Docket Item # 9
BAR CASE # 2008-0115

BAR Meeting
September 16, 2009

ISSUE: Addition and Alterations
APPLICANT: Tony Chan, Falston Development
LOCATION: 532 N. Washington Street
ZONE: OC/Office Commercial

Figure 7. Proposed north elevation.

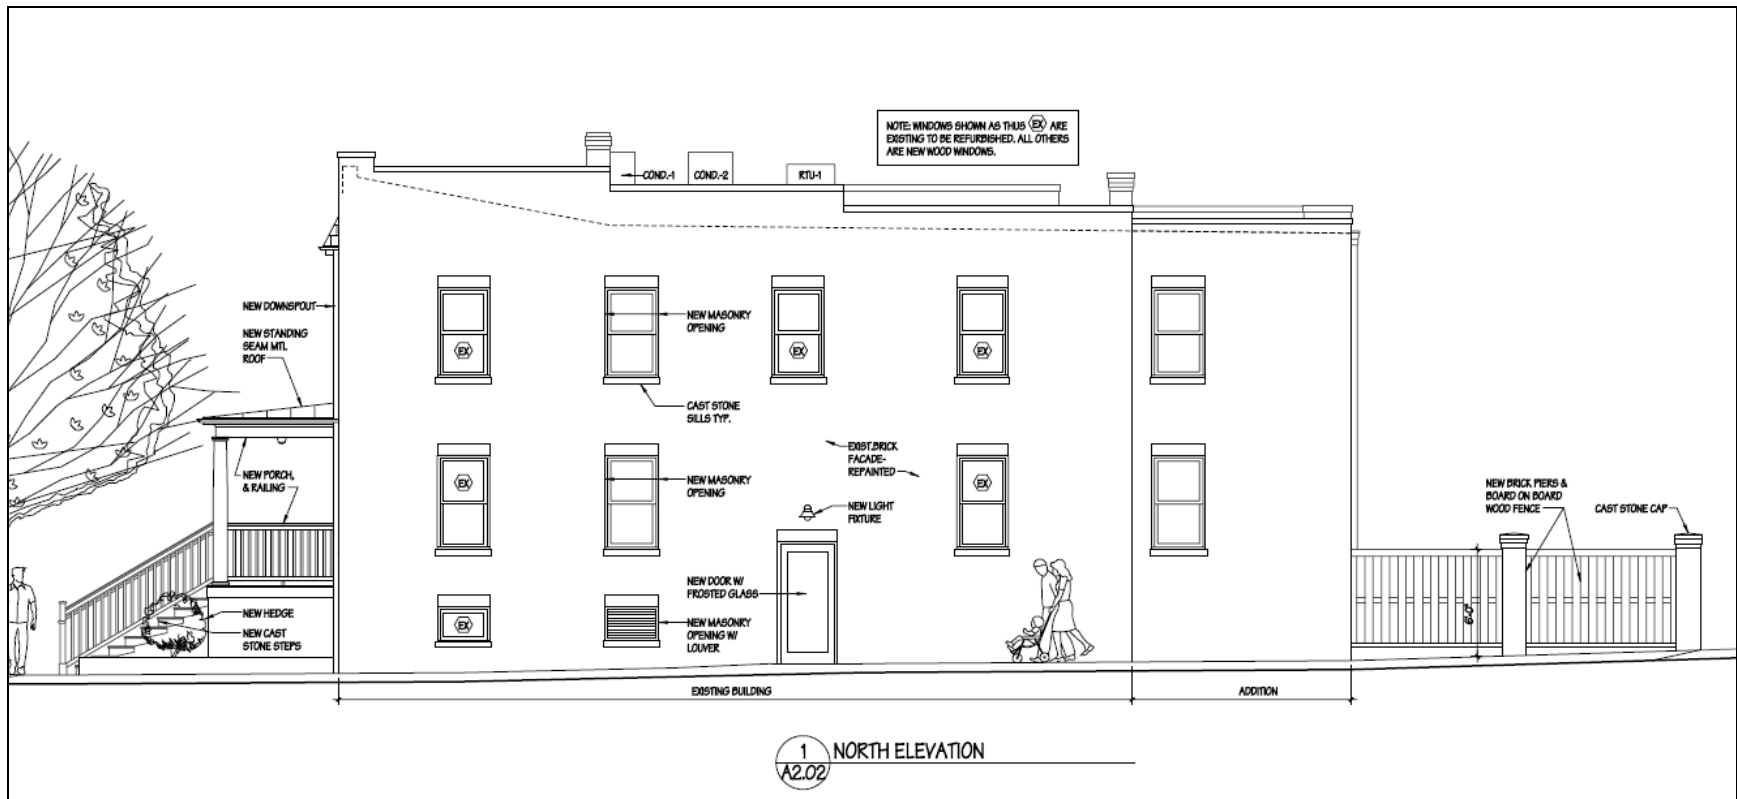
The applicant proposes to create two new window openings, one new louver opening, and one new door opening on this elevation. The proposed wood door will have frosted glass. The brick on this elevation is common brick. Although visible from Washington Street, Staff finds the proposed alterations acceptable.

Figure 12. Proposed rear and side light fixtures.

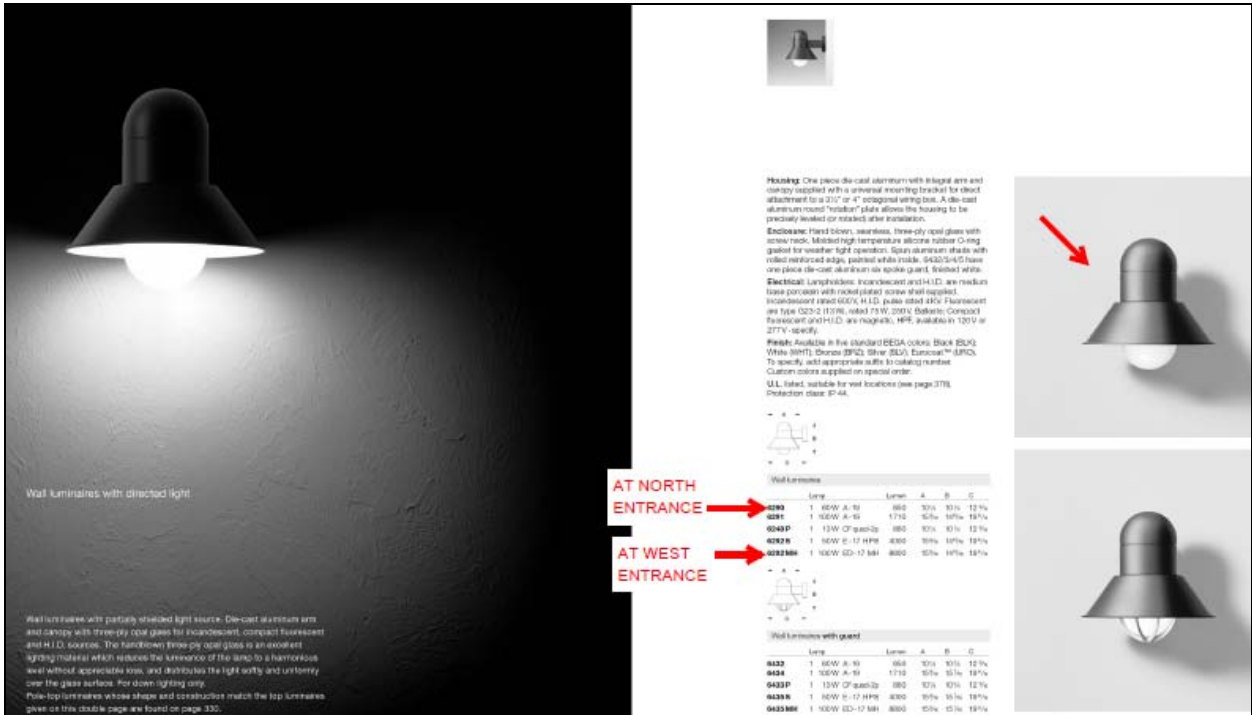
Staff’s only objection to the proposed rear elevation is the proposed light fixture over the window on the infill portion as it looks out of place in this location. Staff does not object to a light fixture on the infill section, but recommends that an alternate location be considered, such as centering the fixture between the windows. The proposed two-story glass portion between the two parts of the addition effectively conveys the sense on the rear elevation that there are two distinct elements.

2. That the wood portion of the proposed fence be painted or stained.
3. That all components of the porch and railing be wood, painted or stained.
4. That the proposed light fixture over the rear left window be centered between the two windows on the infill portion, and that both rear light fixtures be lowered 6-12 inches.
